IDENTIFYING CWP MAIN RO PUMP REPLACEMENT PARTS

The purpose of this Technical Update is to understand and identify the various parts required to replace the Main RO pump on the CWP.

Version 1:

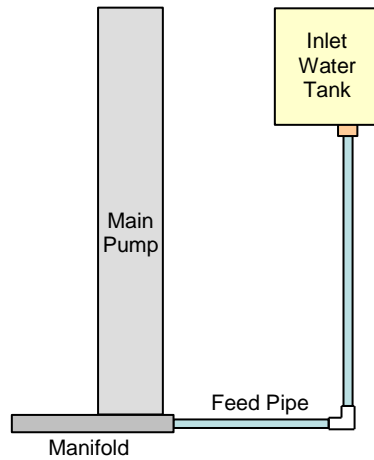
- Single outlet water tank
- Coarse threads in union
- Single feed to the pump via the lower manifold

Version 2:

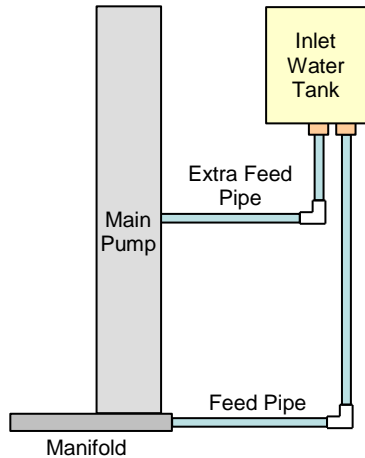
- Dual outlet water tank
- Steep threads in unions
- Dual feed to the pump
 - One feed via the lower manifold
 - An additional feed pipe to the RO pump mid-section

Version 3:

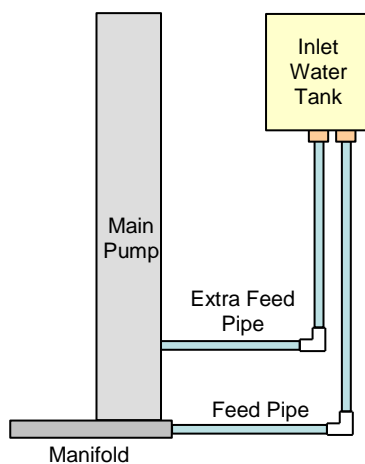
- Dual outlet water tank
- Steep threads in unions
- Dual feed to the pump
 - One feed via the lower manifold
 - Second feed pipe moved to a lower point in the RO pump housing

Early style tank: single outlet/union

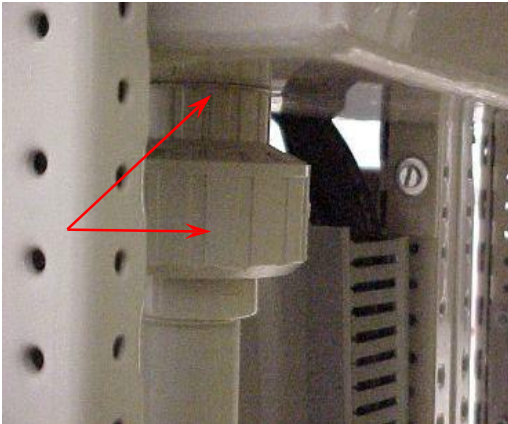
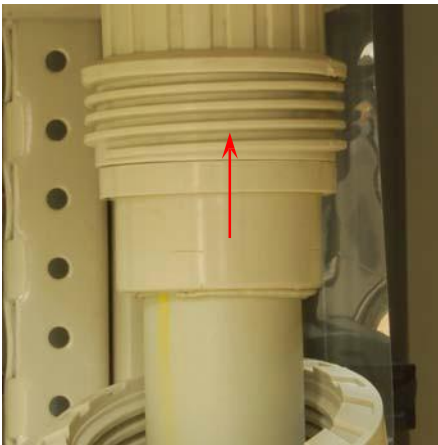
The earlier version of the Inlet Tank had one 25mm pipe that fed from the bottom of the tank to the bottom of the manifold frame and then to the RO pump.

Part being replaced:	Order the following:	
Early style Inlet Water Tank (only)	WTW608011001 WTW606047001	Inlet Water Tank (new style) Feed pipe steep thread to STD
RO Pump	WTW608011001 WTW606001001 3027996 3027997 3027998	Inlet Water Tank (new style) Extra feed pipe kit C-PVC RO Pump CWP 101 & 102, or RO Pump CWP 103 & 104, or RO Pump CWP 106
For CWP 101-104 S/N <100292 add	WTW602043001 WTW602038001 WTW602025001	MCS1 CON1 AUX Contactor

Pump Wire Lead and End cap

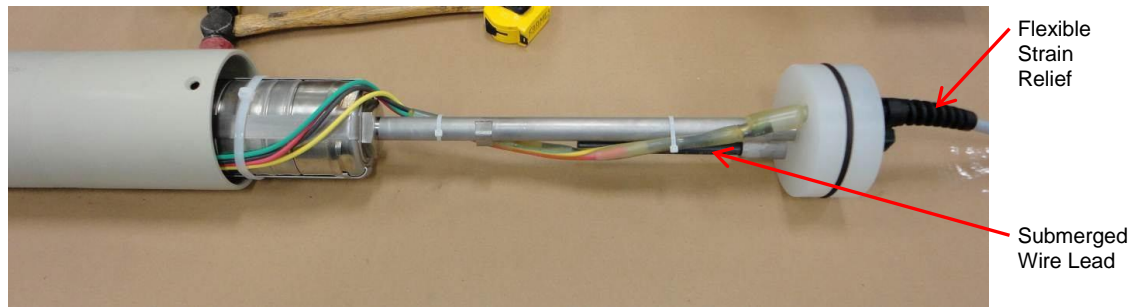
Starting with CWP RO serial number 1299919, a new RO pump wire lead and end cap were implemented into production. As a result, various new spare parts are now available and certain legacy parts have been discontinued due to these design changes.

The new RO pump end cap and wire lead have been changed from the historic Gambro design by increasing the wire gauge from 16 to 14 and by submerging the spliced connection in water for improved cooling and safety. If any electrical failure was to happen at the crimp, it would trip the overload faster due to contact with water. The submerged splice is based on the V/Z Series RO submerged wire lead that has a 10+ years' worth of proven success.

Part being replaced:	Order the following:	
RO Pump (see note)	3027996 3027997 3027998 3028003	RO Pump CWP 101 & 102, or RO Pump CWP 103 & 104, or RO Pump CWP 106 End cap/Wire Lead Replacement (all RO's)
